UNITED STATES PATENT AND TRADEMARK OFFICE

APPLICATION NO.	FILING DATE	FIRST NAMED INVENTOR	ATTORNEY DOCKET NO.	CONFIRMATION NO.
10/809,106	03/26/2004	Peter D. Lee	58632US004	6665

Office Action Summary

DETAILED ACTION

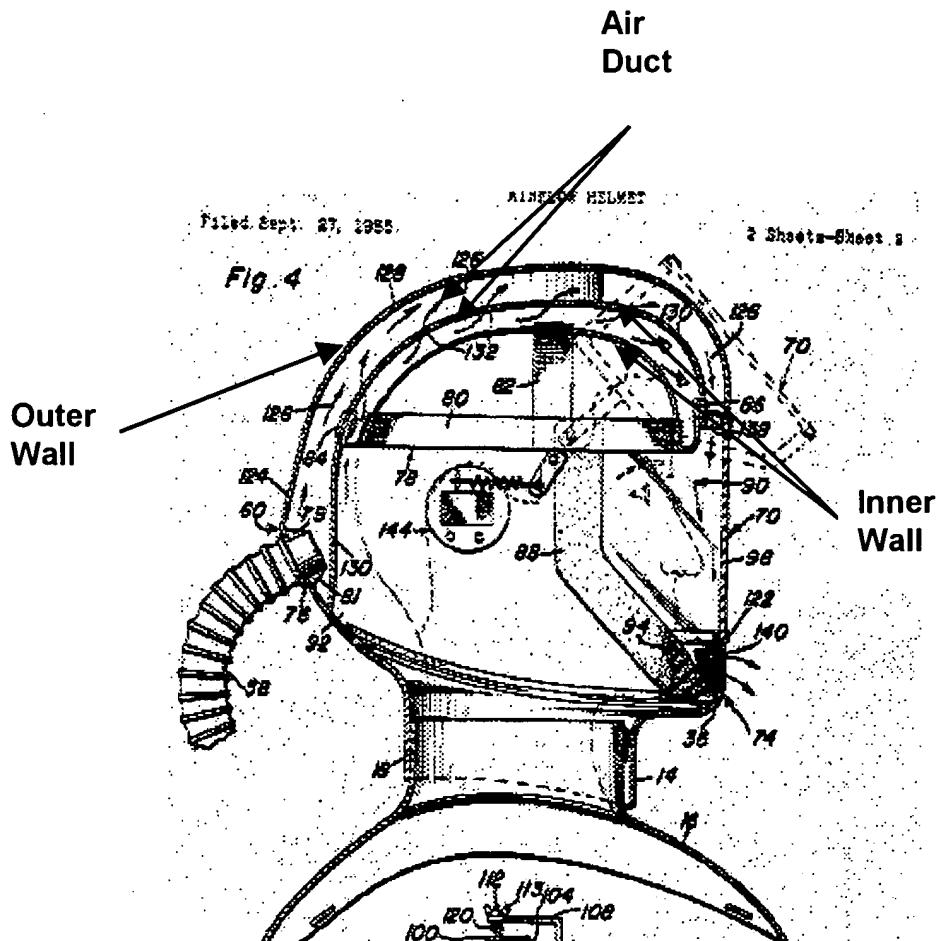
With respect to claim 6, Depping discloses wherein the visor forms at least part of a side wall of the hood (70; inasmuch as the visor is part of the air chamber it inherently forms at least part of a side wall of the hood; Figs. 1, 2, 4).

With respect to claim 10, Depping discloses wherein the air chamber comprises an outer wall of the hood and an inner wall secured to the outer wall around a perimeter edge of the hood to define the air duct there between (see illustration of Fig. 4 below).

With respect to claim 12, Depping discloses wherein the outer wall and inner wall are shape stable (Fig. 4).

With respect to claim 18, Depping discloses wherein the outer wall is a top wall of the hood (Fig. 4).

With respect to claim 19, Depping discloses wherein the top wall and inner wall of the air chamber are permanently secured together (Fig. 4).

With respect to claim 26, Depping discloses wherein the top wall and inner wall of the air chamber are secured together around the perimeter of the hood and are spaced apart inwardly of the perimeter (Fig. 4).

With respect to claim 27, Depping discloses wherein the air duct (at 126) extends across the whole area of the hood above the head of the user and is not confined to the peripheral edge region of the hood (Fig. 4).

With respect to claim 28, Depping discloses wherein the top wall and inner wall of the chamber are provided with smooth internal surfaces shaped to direct the flow of air from the inlet to the outlet without any sharp or sudden changes in direction (Fig. 4).

With respect to claim 29, Depping discloses wherein the inlet opens into the air chamber to assist the air flow to spread out within the air chamber (Fig. 4).

With respect to claim 30, Depping discloses wherein the top wall and inner wall of the chamber are dome-shaped to provide the upper portion of the hood with a recessed area open to the underside over the head of the user (Fig. 4).

With respect to claim 31, Depping discloses wherein the inlet and outlet are provided on opposite sides of the dome-shaped portion of the inner wall (Fig. 4).
